RA-19-0183

H.B. Robinson Steam Electric Plant, Unit No. 2
Docket Number 50-261
Renewed Facility Operating License No. DPR-23R-55

Subject: License Amendment Request to Add New Feedwater Bypass Valves to
Technical Specification 3.7.3

Figure 1
Feedwater System

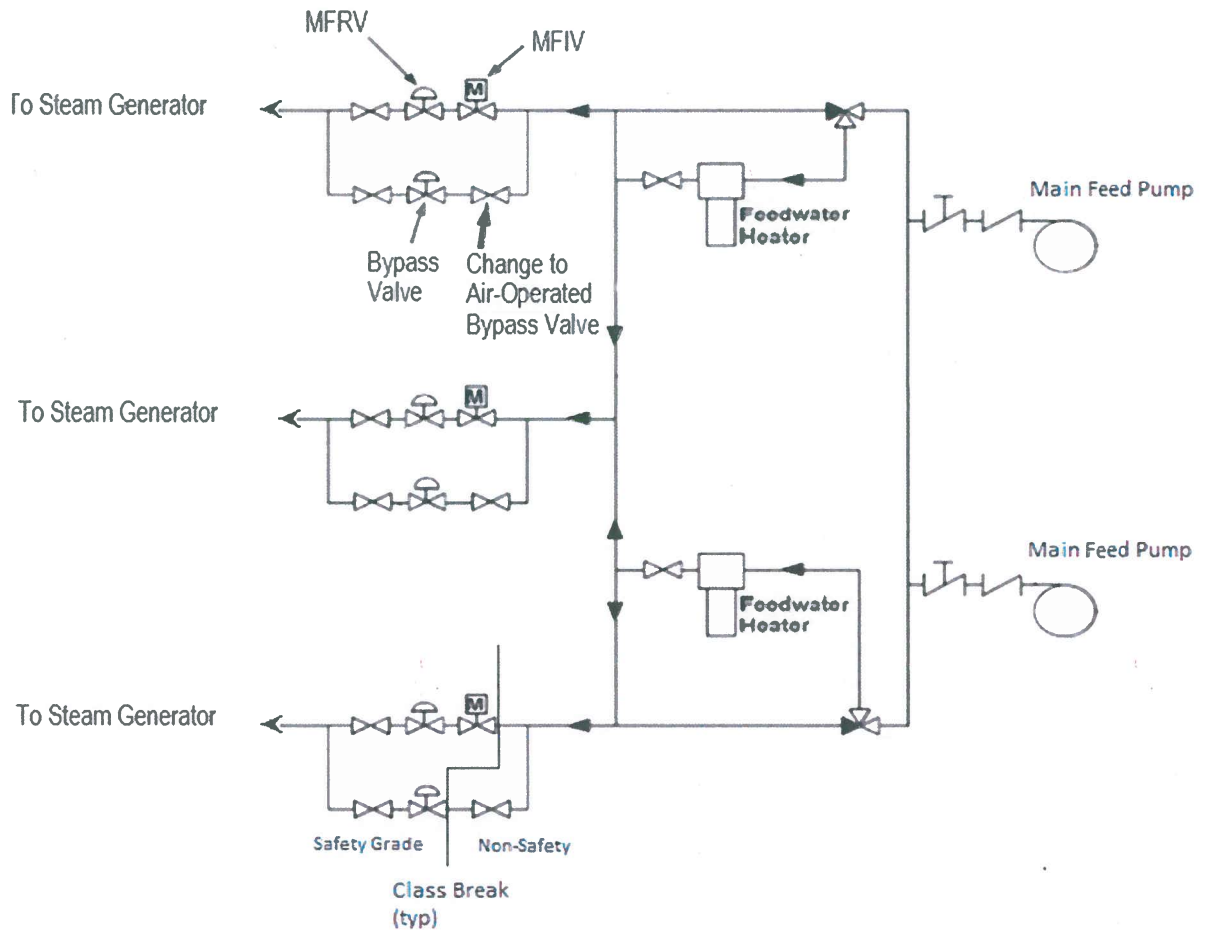
Figure 1 below shows the configuration of the steam generator feedwater flow paths. Each steam generator's feedwater flow path currently has one MFRV, one MFIV and one bypass valve (as identified in the top flow path). HBRSEP2 is implementing a modification under 10 CFR 50.59 to replace the manual valve directly upstream of each bypass valve with an air-operated valve that will also receive a safety injection and feedwater isolation signal to close.

To resolve the single failure vulnerability, Duke Energy is installing a second BV in each of the three feedwater bypass lines under 10 CFR 50.59. The new valves will be air-operated valves (AOVs) installed in series with existing bypass valves FCV-479, 489 and 499. The new BVs will actuate to close on an ESF signal and will replace existing manual valves FW-9A, B & C in the non-safety portion of the system.

The new BVs, FW-9A, B & C, are 4-inch, non-safety grade, Quality Class B, seismically mounted (not seismically qualified), air-operated valves that fail-closed on a loss of air and receive an ESF signal to close. The safety-related ESF signal will be routed through fuses that serve as the Class 1E electrical isolation boundary. The new valves will replace manual valves FW-9A, B & C, which are located upstream of FCV-479, 489 & 499, respectively. The new BVs will be installed via 10 CFR 50.59, will be compliant with design requirements of the feedwater system and will provide a backup isolation function to the existing safety grade bypass valves. See Figure 1.
